ARINC 424 NDB

**Draft 4 of Supplement 23
Discussion/Proposal**

REMOVE XA LEGS TO 400 FT ON MISSED APPROACH

Julien FOUGNION, SII for AIRBUS
Julien ROBIN, AIRBUS

Figure 1: Flown trajectory (in green) during an arrival on VOR05 at LFKF

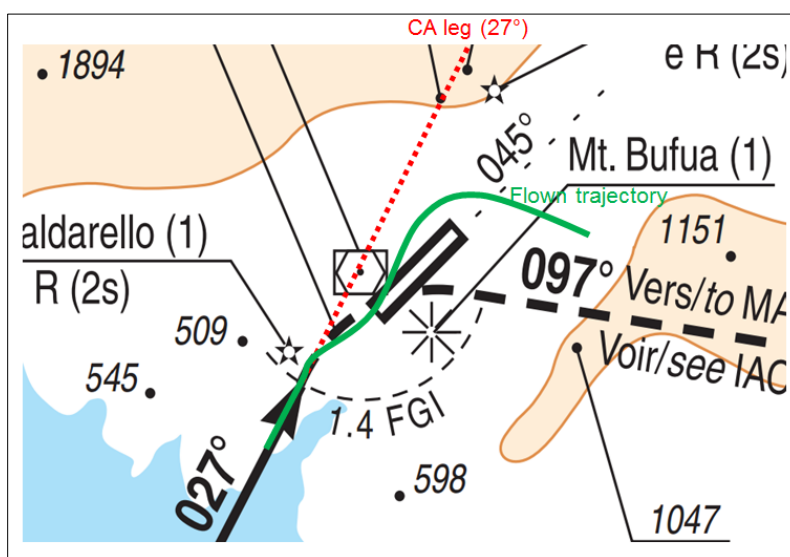
During the flight test, it was noticed that upon initiating a go-around manoeuvre at low height above the runway and after the MAPt, due to the CA leg coded in the final approach segment axis (027°), the aircraft Flight Director commanded an immediate left turn (instead of the missed approach's right turn to 097° expected by the crew), as shown in figure below:

- **Scenario #1** – VOR05 on LFKF **with** CA leg – Final Approach Course not aligned with Runway and MAPt before Runway threshold:
 - CF to MAPt then CA-CF legs combination for AIRAC cycle 1913.
 - CA leg course aligned with Final Approach Course (30°) up to 520ft MSL.
 - Final Approach Course (30°) not aligned with Runway (45°).
 - Right turn > 15° required for Missed Approach (97°).

After passing 100ft AGL, LNAV automatically engaged and crew immediately re-engaged AP, leading A/C to start turning left towards Final Approach Course 30° (so opposite to published missed approach path) with a low dynamic and for approximately 1NM. The left turn was considered very problematic by the pilots since not in accordance with the chart asking for an immediate right turn.

Based on those elements, AIRBUS considers that xA legs to 400ft AGL as first leg of missed Approach procedures that are followed by immediate turns should not be coded when the Final Approach Course is not aligned with Runway centreline or when the MAPt is not ending at the runway threshold.
